ENGINE - LP COMPRESSOR - INCORPORATE ANTI-FRET COATING ON THE ANNULUS FILLER ASSEMBLY
FRONT FACE - CATEGORY CODE 6 - MOD.ENG-72-0096

V2500-ENG-72-0096

Modification of the Annulus Filler Assembly
Fig.1, Sheet 1 of 2

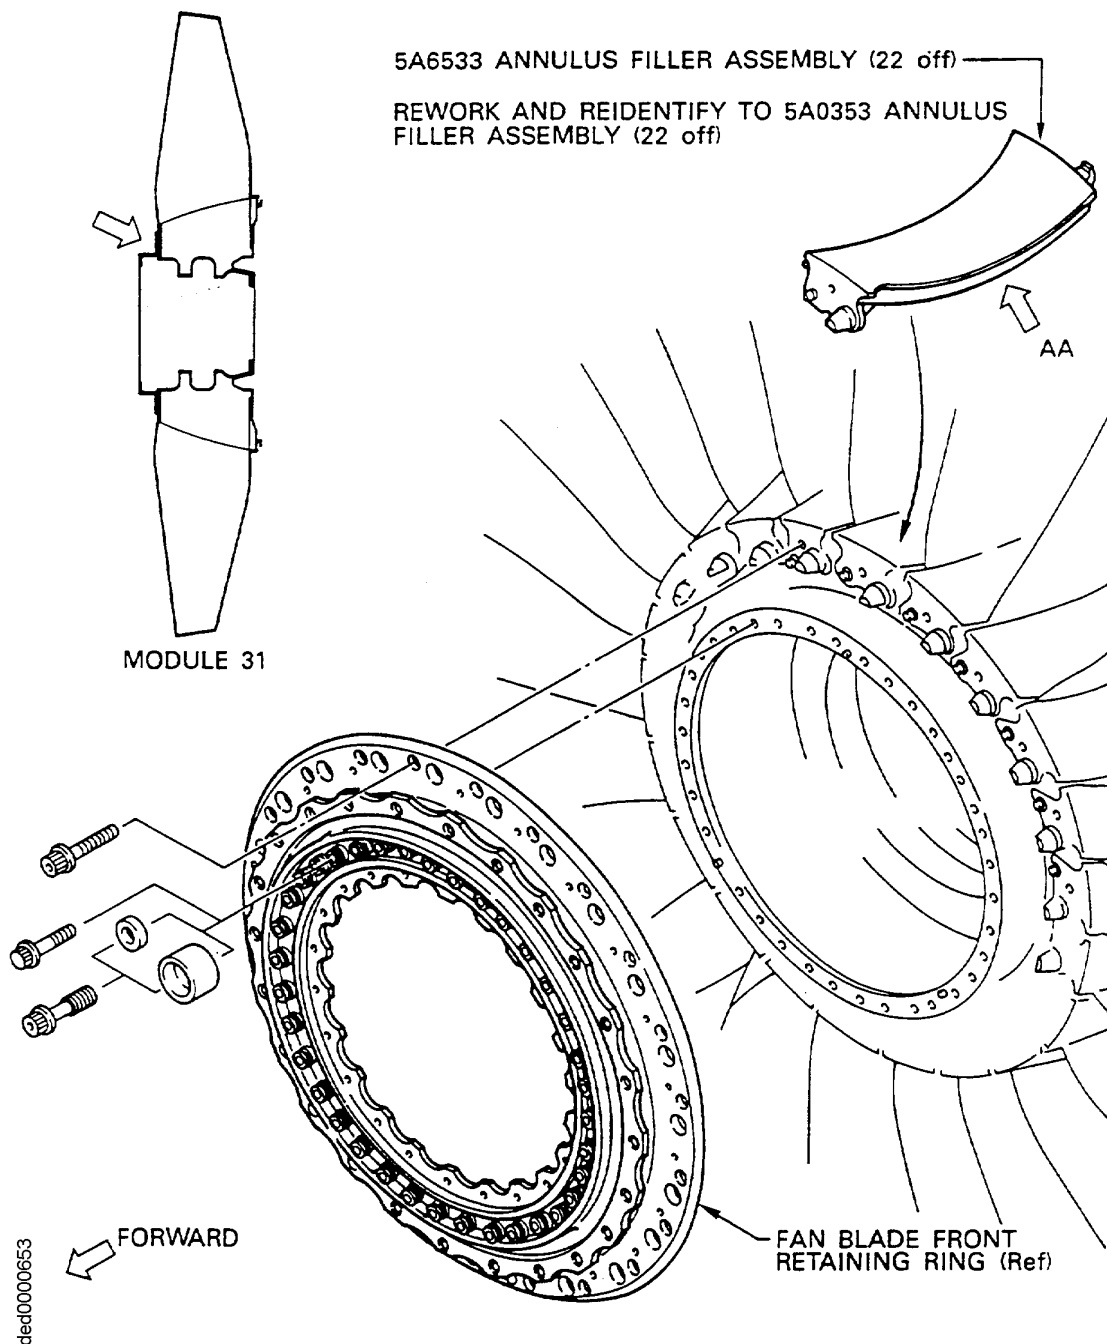
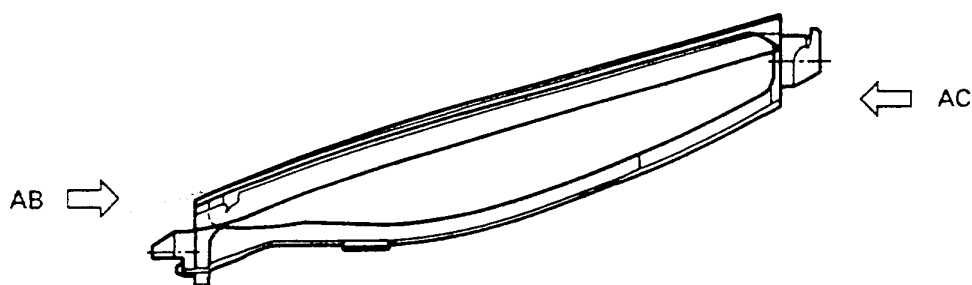
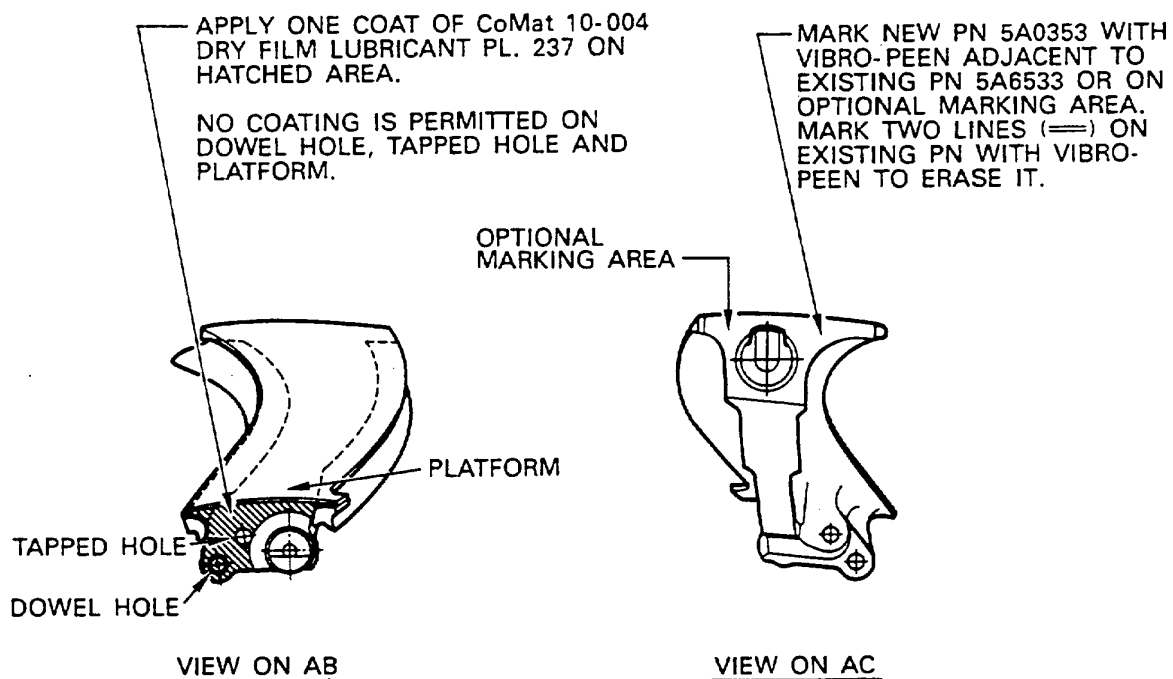
- (1) The changes introduced by this Service Bulletin are as follows:
- (a) One coat of the dry film lubricant is applied to the front face of Annulus Filler Assembly to prevent fretting between the Annulus Filler Assembly and the LP Compressor Fan Blade Front Retaining Ring. (See Figure 1).
 - (b) Existing Part Number of the Annulus Filler Assembly has been changed to a new Part Number.
- (2) Existing Annulus Filler Assembly can be reworked to a new configuration. (See Figure 1).

Procedures	Supplementary Information	
(1) Apply one coat of CoMat 10-004, Dry Film Lubricant PL.237, to each front face of the 22 PN 5A6533, Annulus Filler Assemblies, by the approved procedures in the Standard Practices /Processes Manual, 70-38-03.	Refer to Figure 1, 1.K. (3) and 1.K. (4). Coating thickness must be 0.00012 to 0.00059 in. (0,003 to 0,015 mm).	
(2) Renumber with Vibro-peen adjacent to the old part number marked on each rear face of Annulus Filler Assemblies by the approved procedures in the Standard Practices /Processes Manual, 70-09-00.	Refer to Figure 1, and 1.K. (3) Existing Renumber 5A6533 5A0353
